PRODUCT SUPPORT BULLETIN BULLETIN NO. 347

MACHINE: **Model C Spike Driver
Model E Anchor Applicator
M3-B**

SUBJECT: **Screw Terminal Toggle Switches**

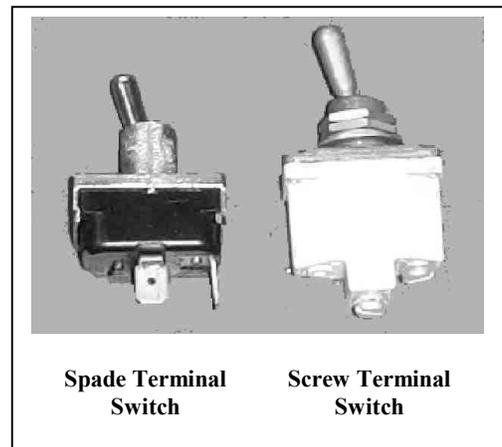
There have been some reported problems with the spade style toggle switches used on these machines. After a time, the wires may become loose on the switch and cause an intermittent connection. This can result in extra heat at the connection.

We have discontinued using spade connectors on new production units of these machines. When it becomes necessary to replace a spade terminal switch, it is recommended that the screw terminal replacement switch be used. Check the cross-reference chart on page 2 to locate the correct part number when ordering a replacement switch.

Anchor Applicators from s/n 680240 through 680250 used McGill screw terminal switches. These switches were found to be unreliable due to water being able to leak into the switch. These switches were replaced with Cutler-Hammer switches starting with machine s/n 680251. The Cutler-Hammer switches provide superior sealing against the weather. Any replacement switches ordered will be Cutler-Hammer switches.
